Kind : LBA Airworthiness Directive AD-Note no. 78 -

Subject : Safety measures for inspection hole cover in fuselage.

Effectivity : All ASW 20_s. serial numbers 20 001 through 20113, except 20111.

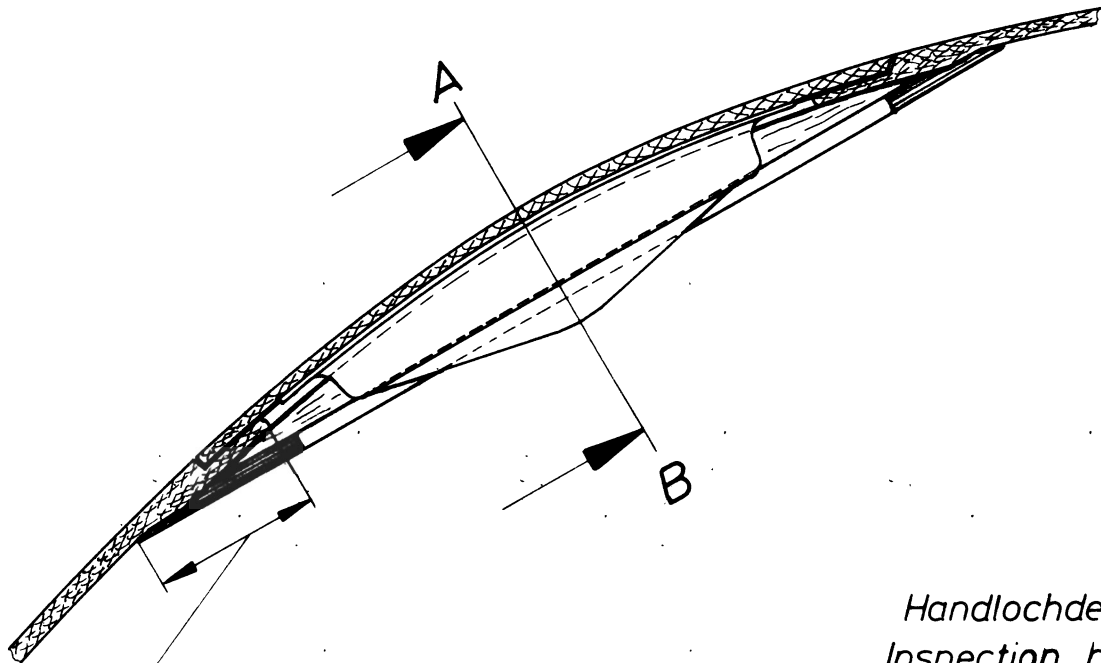
Instructions :
TN 4a :
By means of a plywood ring shield (P/N 200.11.0127) the hole of which is narrower than the smallest width of the inspection hole cover it is prevented that the cover can get into the fuselage.

Prior to glueing in the plywood ring all the glue joints must be well fitted and sanded.
A mixture of
100 parts in weight of Epikote 162
38 parts in weight of Epikure 113,
thickened by 10 - 15 parts in weight of Aerosil,
may be used as a glue. However, it may be as well used Aerodux or a two-component epoxy glue (like UHU-plus)

For the cover itself or the bungee no modification is necessary.
See drawing on sheet 4 of this TN.

After the installation the plywood ring shield and the sanded areas around it are preserved by paint or epoxy resin.
